BCA ASSESSMENT REPORT

**Metcash Distribution Centre
Bungarribee Industrial Estate Huntingwood NSW**

PROJECT MUSTANG

Revision 1

Figure 1 – Site Plan detailing the extent of the warehouse addition.

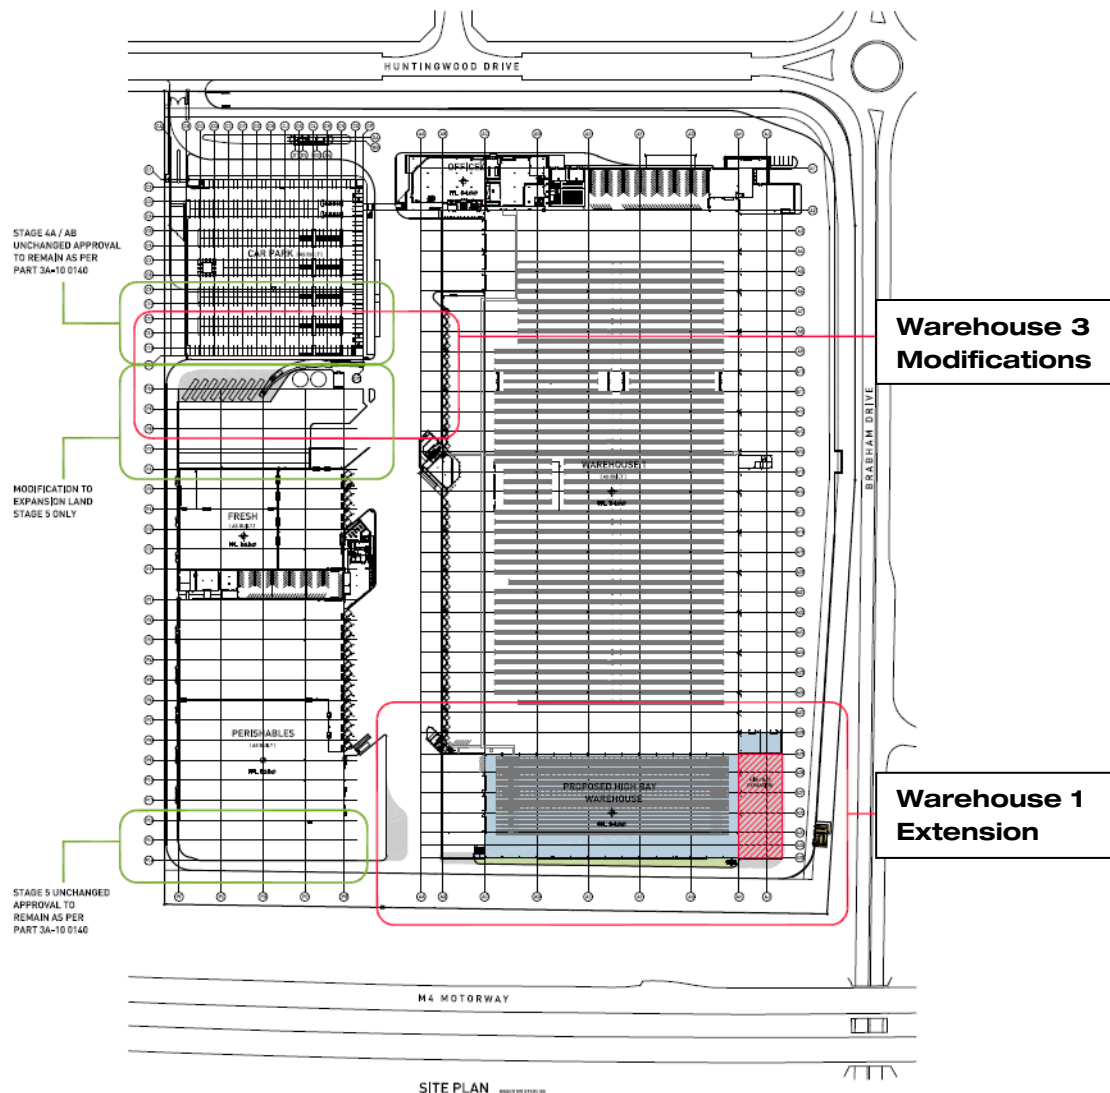
Note 1: The perimeter access road in the South East corner of the new addition appears to be greater than 18 metres from the building. As such, either design changes or modifications to the Base Building Fire Engineered Alternative Solution addressing the Performance Requirement CP9 is required in consultation with Fire & Rescue NSW.

Note 2: The proposed modifications to the north-west corner of Warehouse 3 (stage 5) are compliant with the provisions of C2.4.
